# SERVICE BULLETIN

**Machines/Models:** MX Series  
Work Platforms

**SERVICE BULLETIN: 94.5, THE INSTALLATION OF THESE LABELS IS MANDATORY!**

**DATE:** March 21, 1994

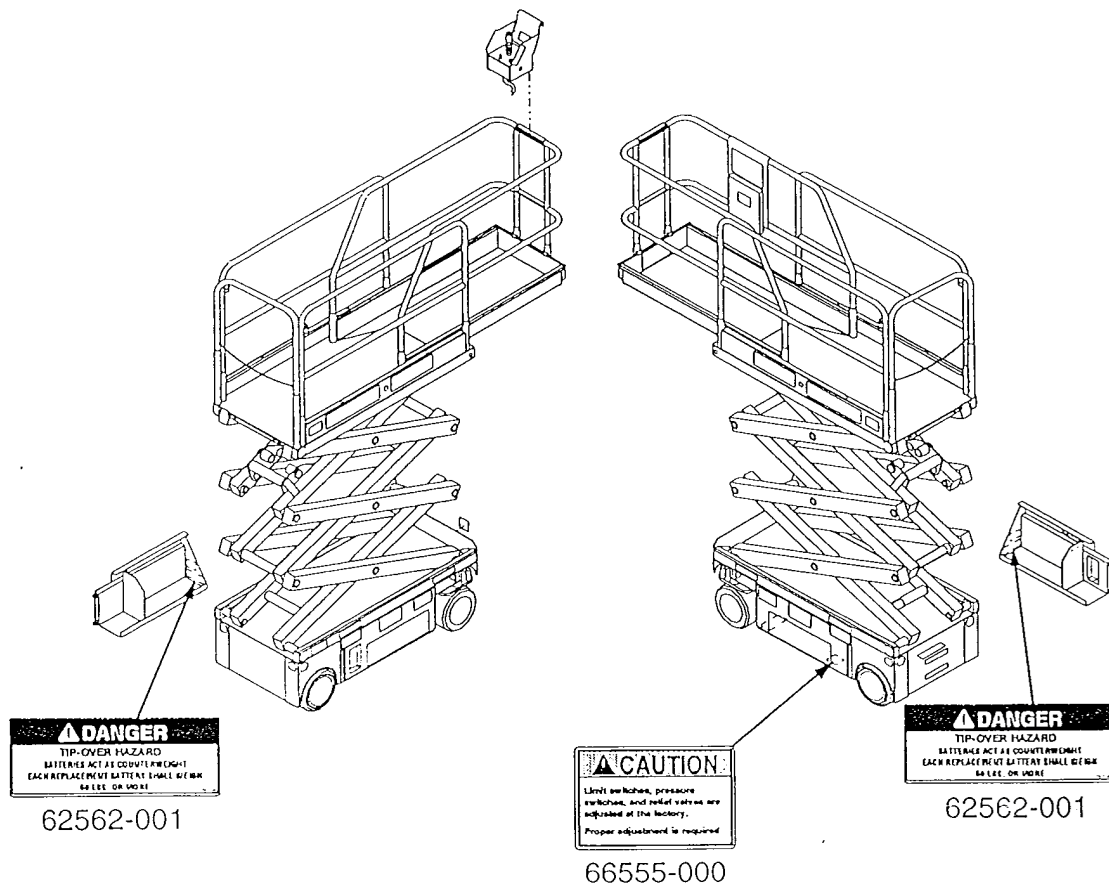
**OPERATION REQUIRED:** Installation of three labels.

**PARTS REQUIRED:** 66555-000, Qty. 1; 62562-001, Qty. 2.

**PROCEDURE:** Install labels as shown in the following illustration.
